## ✓ St. Mary's & I-10 Bus Stop – SW Corner (SunTran # 13690)

ADA accessibility Score: 0

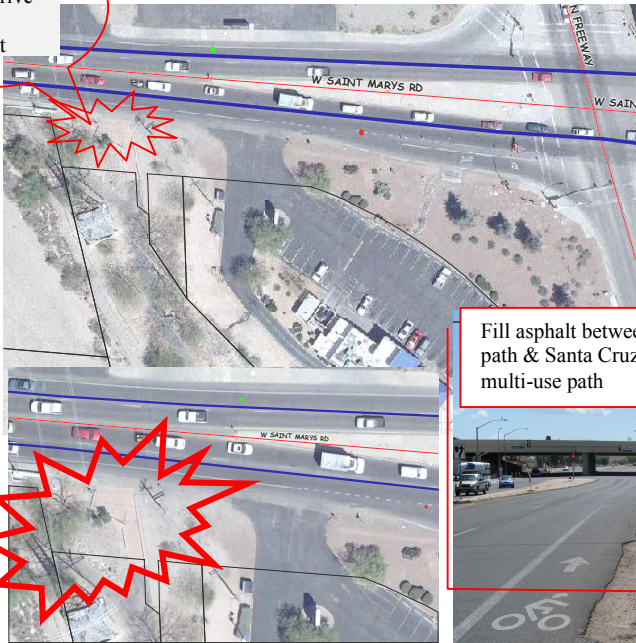
Issue(s): Stop not connected

Solution(s): create/improve connection to stop from west. Move stop to Santa Cruz River Park multi-use path. Fill asphalt between bike route & multi-use path. Remove 3-post ends & concrete anchors (Safety Issue!!!) . Create pedestrian path in front of Burger King to connect stop to ADOT sidewalk crossing for underpass to east

Stop location  
west of drive  
way to  
restaurant

Remove 3-post ends & concrete  
anchors – Safety Issue – sticking out  
of ground 3-5” - hard open edges

Fill asphalt between bike  
path & Santa Cruz River  
multi-use path

**Stop completed:** Stop connected to sidewalk & riverwalk west of bus stop. Safety issue was corrected and road asphalt was extended to new sidewalk and bus stop pad with asphalt extension to Burger King parking lot. Further improvements to create sidewalk east of the bus stop in front of business to I10 frontage road require engineering and design.
